REVIEW OF TRAC CALCULATIONS FOR CALVERT CLIFFS PTS STUDY

J.H. Jo and U.S. Rohatgi

Date Published — April 1985

LWR CODE ASSESSMENT AND APPLICATION GROUP
DEPARTMENT OF NUCLEAR ENERGY, BROOKHAVEN NATIONAL LABORATORY
UPTON, LONG ISLAND, NEW YORK 11973

Figure 2.3 Transient 1: System Pressure

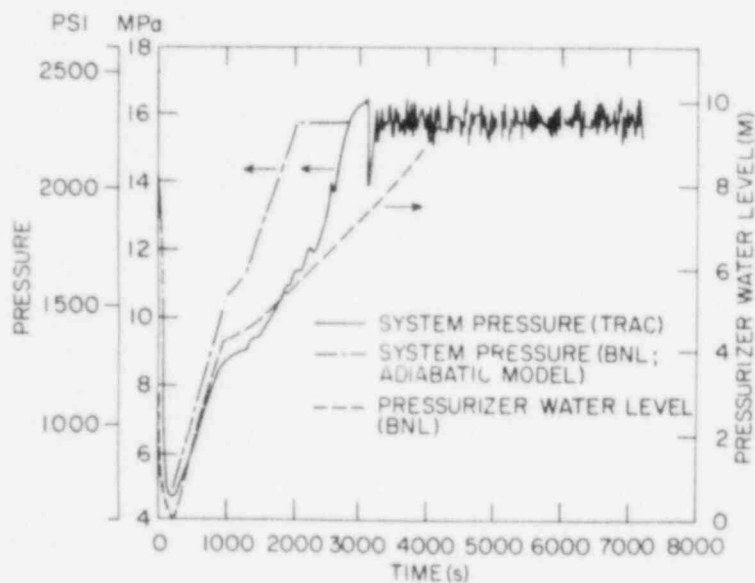
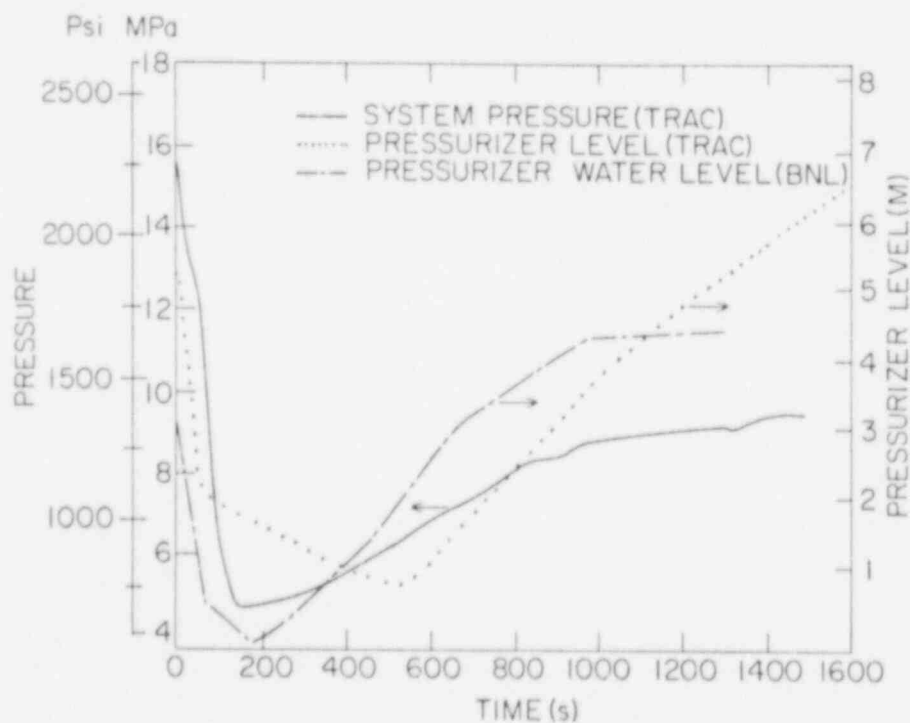
Figure 2.3 shows the system pressures as calculated by TRAC and the BNL staff. The BNL pressure is calculated on the assumption of adiabatic compression during the filling stage. As discussed in the preceding section, the adiabatic assumption yields the highest rate of pressure increase during compression. The actual pressure is expected to be lower than this, as is the case in this calculation. The figure also shows, for comparison, the water level in the pressurizer as calculated by BNL. As expected, the pressure and the BNL water level behave similarly. However, the TRAC pressurizer level decreases while the TRAC pressure increases between 170 and 550 seconds, as shown in Figure 2.4. This appears to be contradictory.

Figure 2.5 Transient 1: Steam Generator Pressure

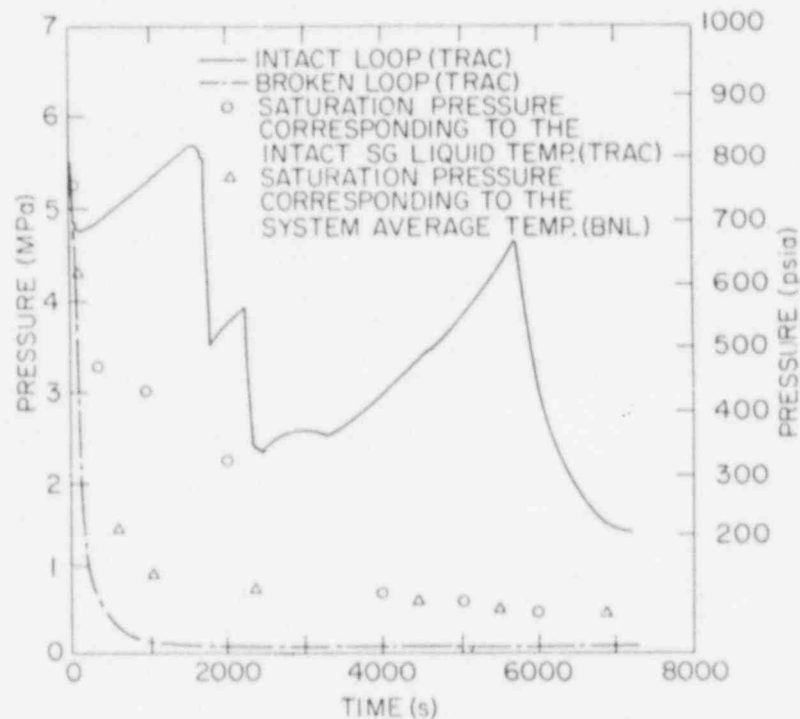
Figure 2.5 shows the TRAC pressure of the secondary sides of both steam generators. The saturation pressures corresponding to the BNL average temperature and the TRAC intact steam generator temperature are also shown in the figure. These would be the expected pressures of the steam generators if the equilibrium condition prevails. The broken steam generator pressure stays at the atmospheric pressure as it becomes empty, as expected. However, the intact steam generator pressure remains much higher than the saturation pressure and also shows several sharp turns. A similar steam generator pressure response is observed in several other transients when the steam generator is being filled with cold AFW. This is apparently related to the severe non-equilibrium effect caused by the TRAC condensation model. It appears that the TRAC condensation model underpredicts the condensation rate and, thus, overestimates the non-equilibrium effect. However, this is not expected to alter the course of the rest of the transient significantly, since the SG pressure is not involved in the control of the system after the initial 100 seconds in this transient.

Figure 5.4 Transient 6: Secondary Pressures

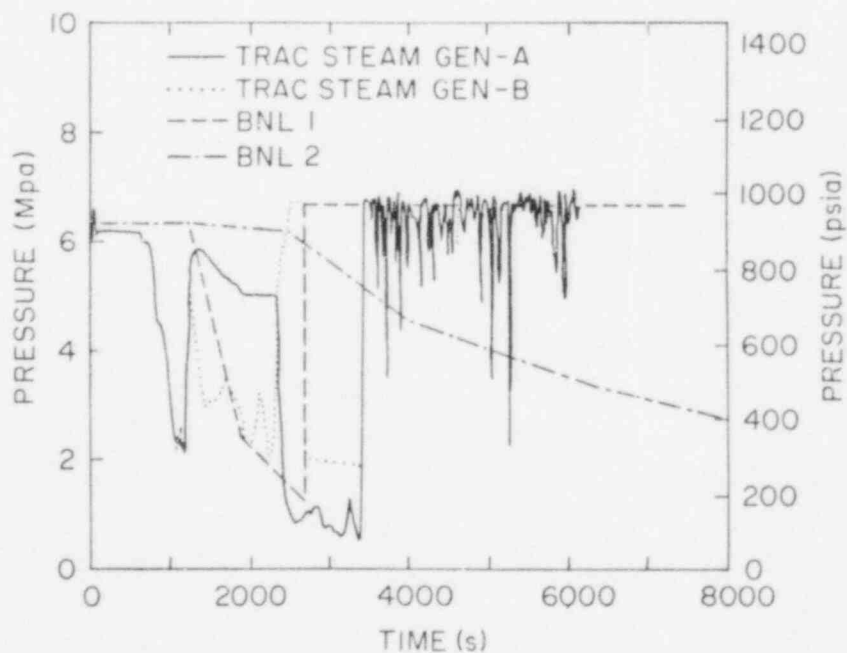
Figure 5.4 shows that the SG pressure for both the TRAC and BNL 1 calculations rapidly decreases due to the temperature drop following the AFW initiation. It also indicates that the SGs are completely filled at about 3000 seconds for both calculations. On the other hand, the BNL 2 results show that the secondary side pressure stays high and then starts to decrease slowly. The SGs are estimated to be full at about 9500 seconds according to the BNL 2 calculation. For both the BNL 1 and BNL 2 calculations, the temperature is expected to continue to decrease beyond 6000 seconds, until it eventually reaches the steady-state temperature, where the decay heat balances with cooling due to charging and AFW flow, if the AFW flow persists. We estimate this temperature to be 300°K and 380°K for the BNL 1 and BNL 2 cases, respectively. However, the feedwater supply system may run out of water long before that time, especially for the higher AFW flow case (BNL 1).

The TRAC calculation shows severe asymmetric pressure and pressure oscillation between the two steam generators (Figure 5.4) when the AFW is introduced. This appears to be due to condensation caused by introduction of a large amount of cold AFW. However, this phenomenon may not affect the primary pressure and temperature significantly, since the overall cooling may depend on the total amount of AFW rather than its distribution. Also, this phenomenon is not expected to happen for the normal AFW flow rate case.

Figure 7.4 Transient 9: Steam Generator Secondary Side Pressure

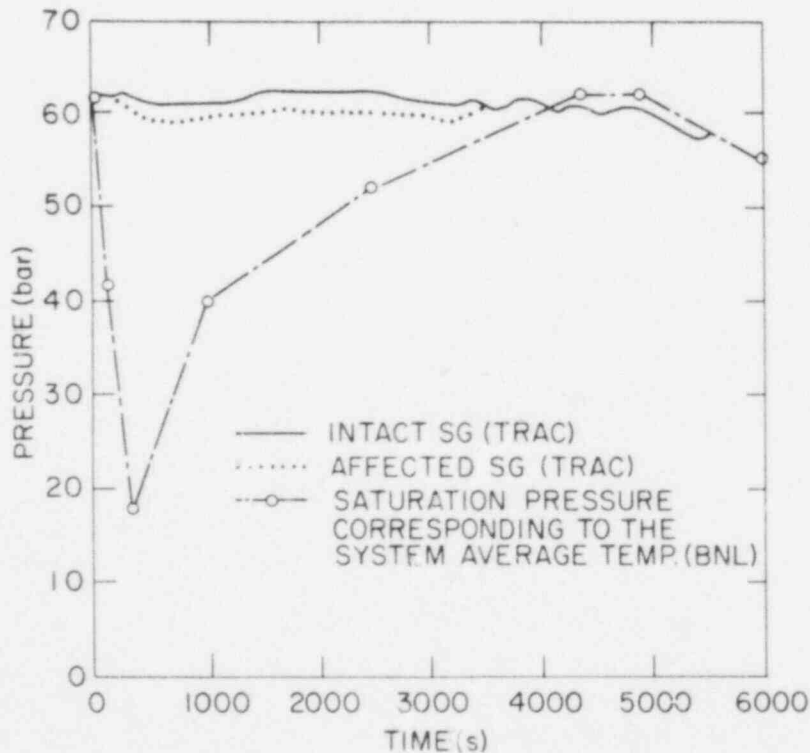
Figure 7.4 shows the TRAC pressure in the secondary sides of the SGs. The pressure of the affected SG remains near TBV set point (61.1 bar) since it is completely full at 130 seconds. However, the intact SG pressure is also shown to stay above 60 bars even during the initial 300 seconds when the temperature declines steeply. This appears to indicate a severe nonequilibrium effect, which is observed in several other transients. The actual pressure is expected to be somewhere between this pressure and the saturation pressure corresponding to its liquid temperature. Both steam generator pressures start to decline at 4800 seconds when AFW is initiated, as they should.

Figure 1 Transient 1

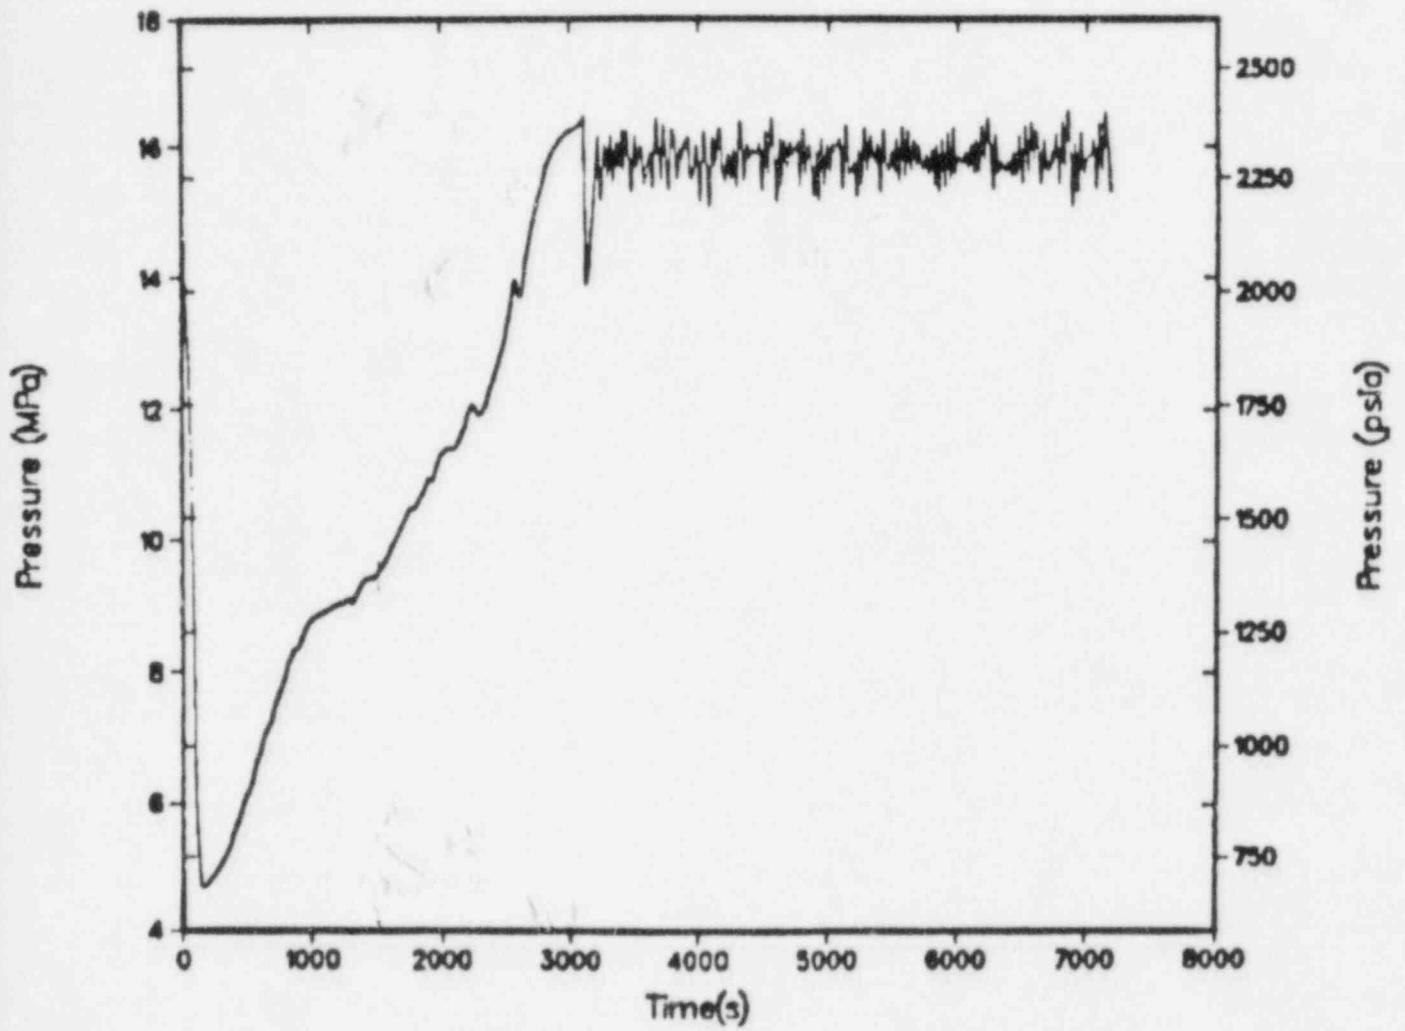
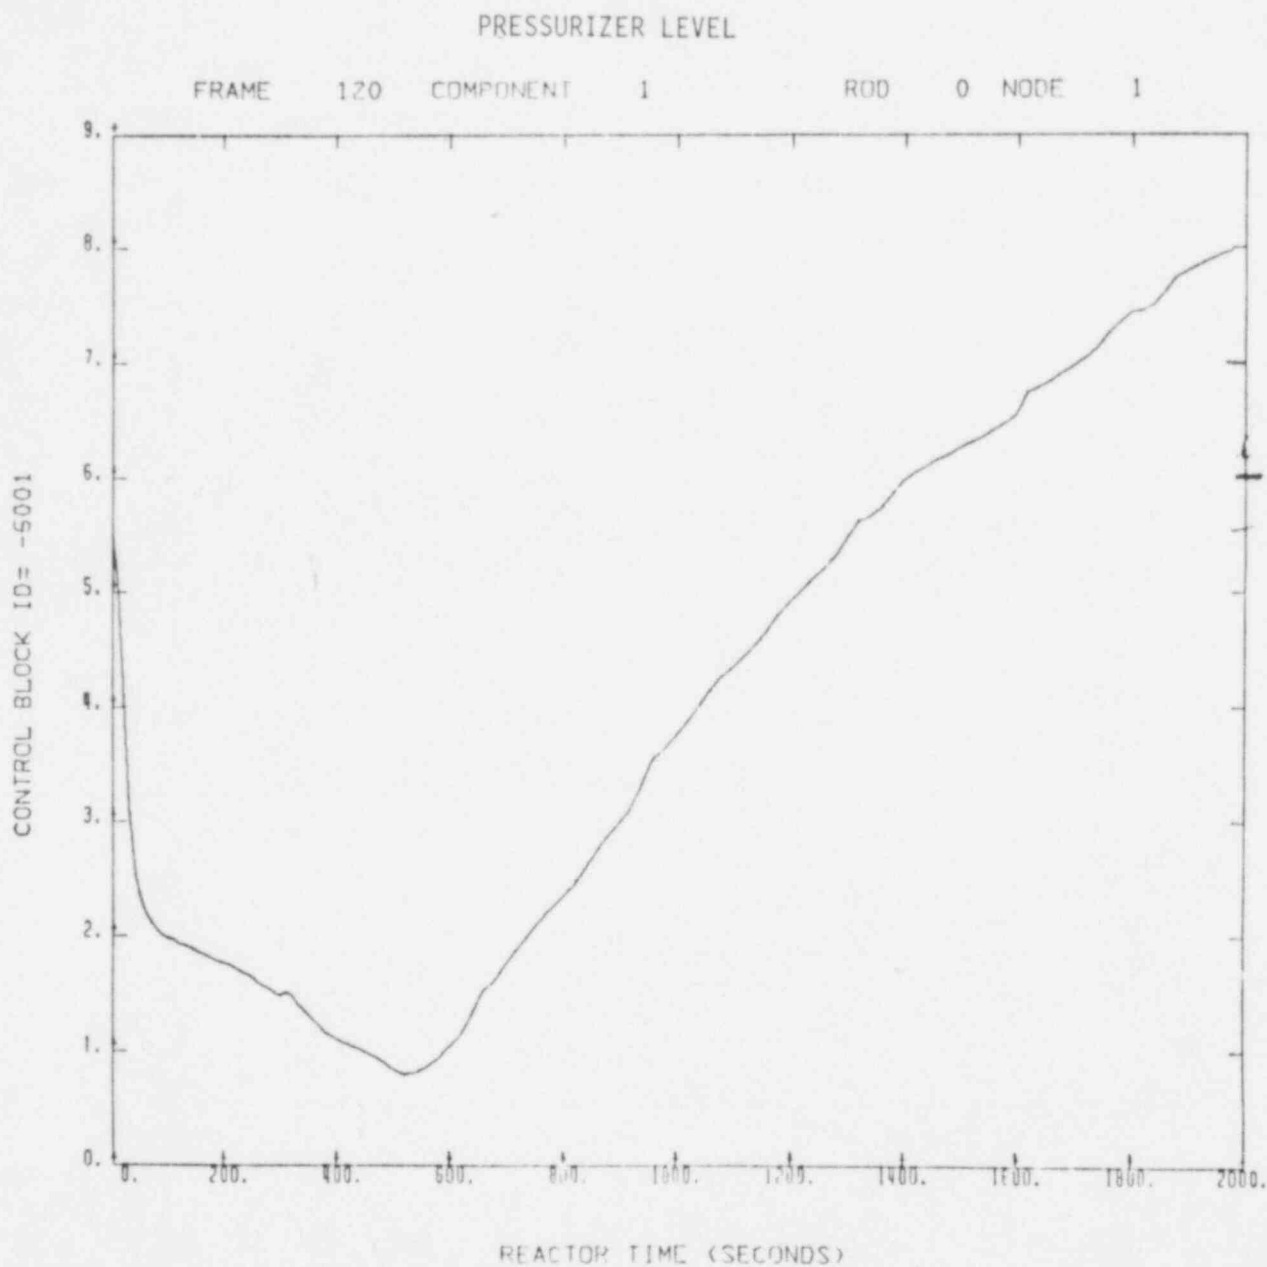
This transient was initiated by a 1-ft² break at the main steam line during the HZP operation. There was a misstatement in Table 4.1 (Sequence of Events of Transient 1) of the LANL draft report that the minimum pressure was reached at 700 seconds. Figure 1 (Figure 4.2 of the LANL report) shows that the minimum pressure was reached at about 170 seconds. Figure 2 showed the pressurizer level was decreasing while the pressure of the primary system was increasing between 170 seconds and 550 seconds. This appeared to be contradictory.

Figure 3 Transient 1

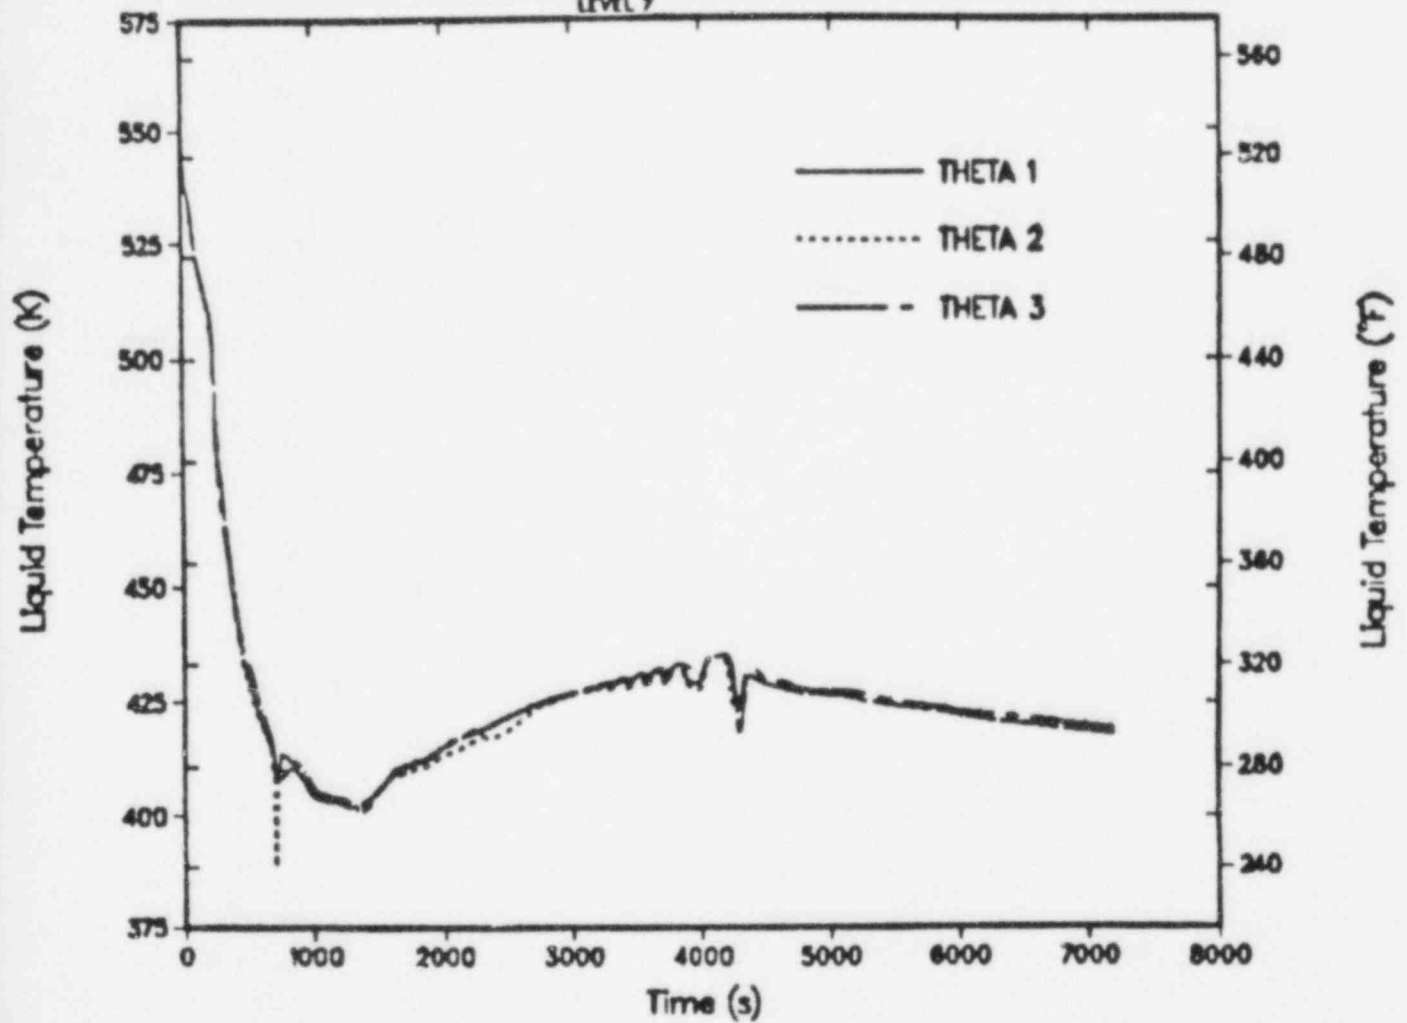
The downcomer liquid temperature (Figure 3) increased substantially from 400°K to 425°K between 1300 seconds and 3000 seconds. However, the decay heat did not appear to be large enough to sustain this temperature rise. A simple calculation based on the energy balance indicated that the temperature should level off during this period. Part of this temperature rise may be due to the gradual mixing of the hotter upper head liquid with the bulk of the liquid in the system. This point will be further checked in the detailed review.

Figure 4 Transient 1

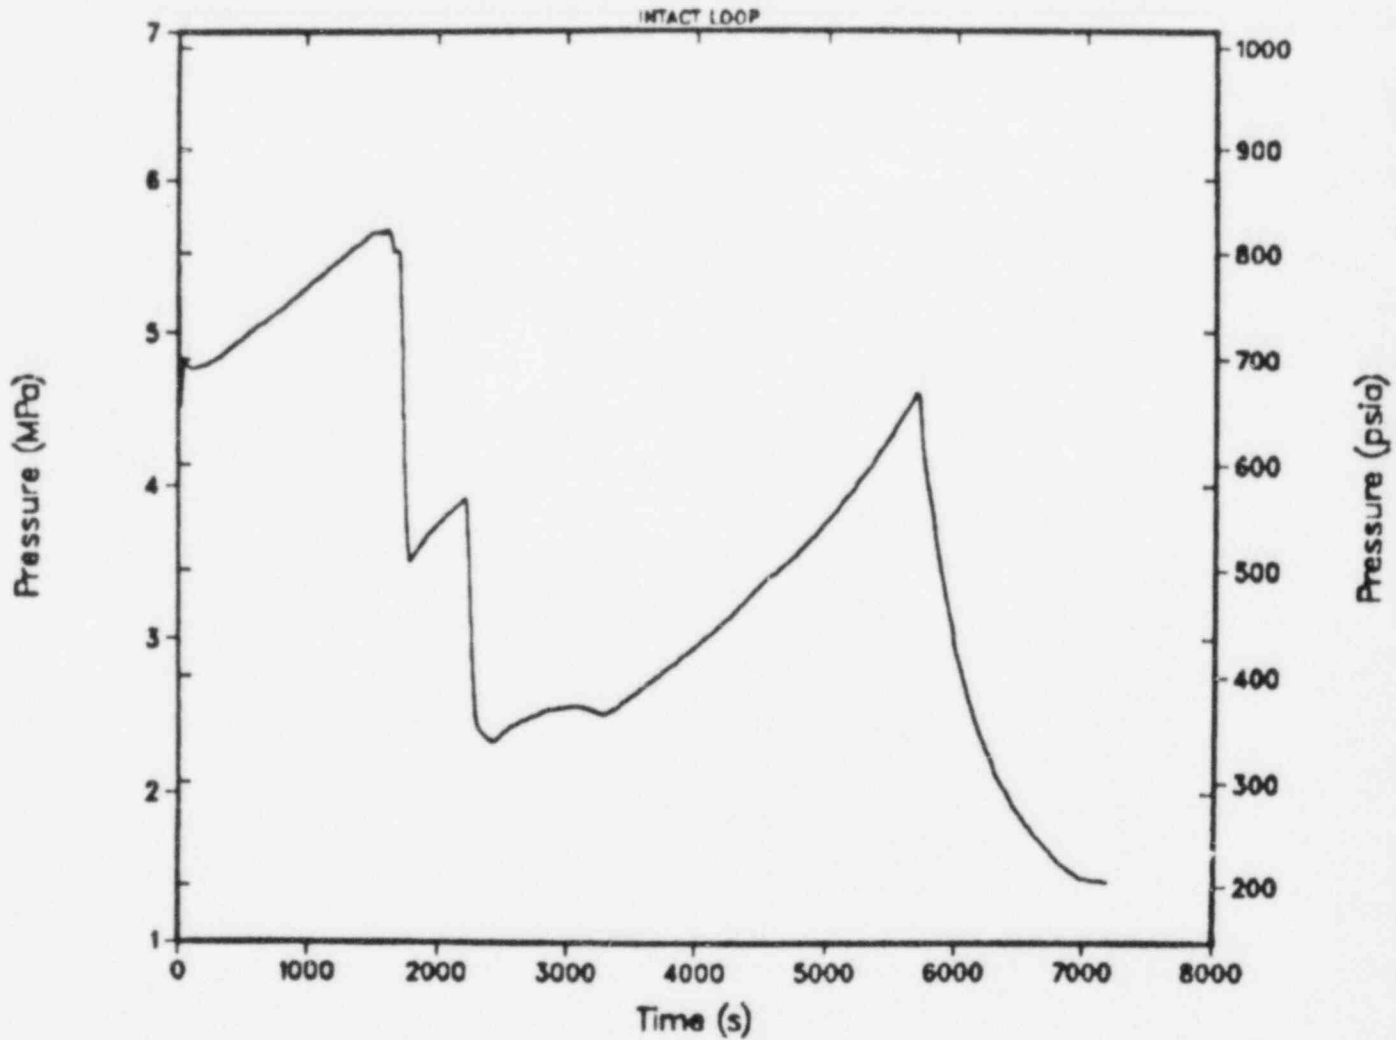
The steam line pressure of the intact loop (Figure 4) showed a sharp reversal when the intact steam generator was isolated at 20 seconds and continued to increase. This appeared to be contradictory since the primary side temperature of the intact loop continued to decrease during this period.
